FREE Studio Plus v1.8.0

Release Notes

05/2025

9MA10300.09

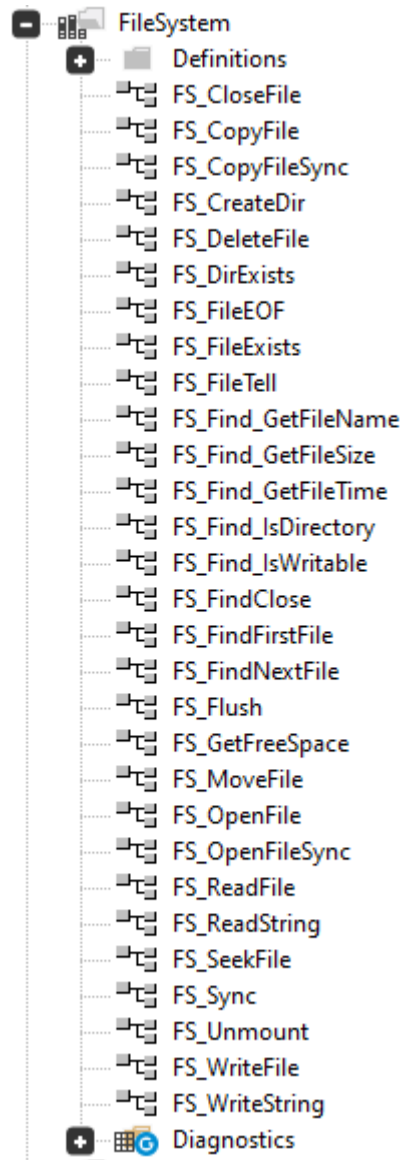
- Add EEV target variables in Programming

Global Variables Group: **System_EEV0** (ver.1.0.0)
Location: Target

Name	Type	Address	Description
sysEEV0OpeningReq	INT	%MW700.0	Valve opening (request)
sysEEV0OpeningCurr	INT	%MW701.0	Valve opening (current)
sysEEV0Status	INT	%MW702.0	Status
sysEEV0Alarms	INT	%MW703.0	Alarms
sysEEV0Info	INT	%MW704.0	Info
sysEEV0Commands	INT	%MW705.0	Commands

Below the new Target Data Blocks folder in BACnet_counters

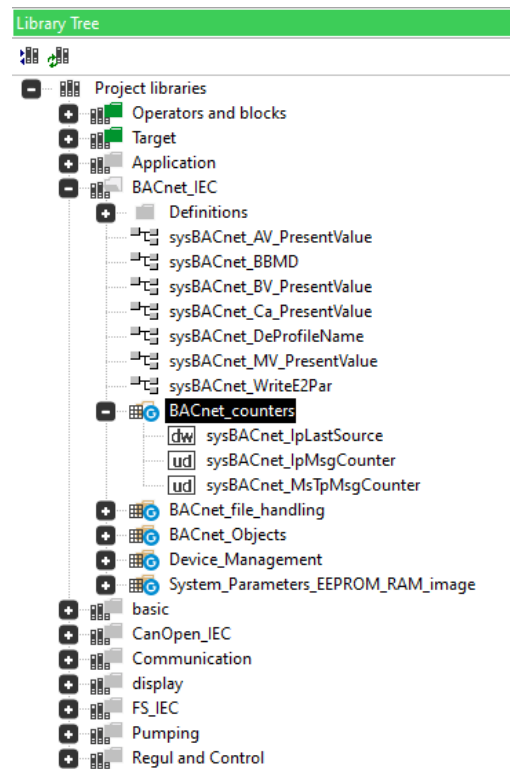
- Introduced Target Data Blocks that counts the number of BACnet IP and BACnet MS/TP messages for the controller. In case of BACnet IP is also stored the IP address of the last message received:
 - sysBACnet_IpLastSource AT %MB5003.0: DWORD;
{ DE:"Source IP address of last BACnet received message. Each part of the IP is stored in the DWORD starting from the MSB using format: IP4 IP3 IP2 IP1" }

- sysBACnet_IpMsgCounter AT %MB5004.0: UDINT;
{ DE:"BACnet IP received message counter" }

- sysBACnet_MsTpMsgCounter AT %MB5005.0: UDINT;
{ DE:"BACnet MSTP Token, Poll for Master or Reply to Poll for Master received message counter" }

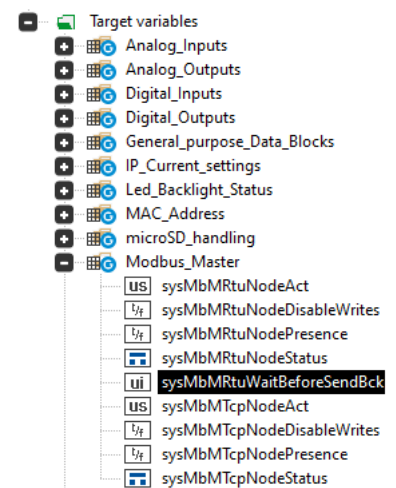
To solve this a new Target DataBlock has been realized to set a wait-before-send time between this kind of messages.

- sysMbMRtuWaitBeforeSendBck AT %MB5002.0 : UINT; { DE: "Wait before send time used by functions sysMbMRTU_FCxx(), value is lower limited to 50 [ms]" }
- located in Target variables\Modbus_Master:
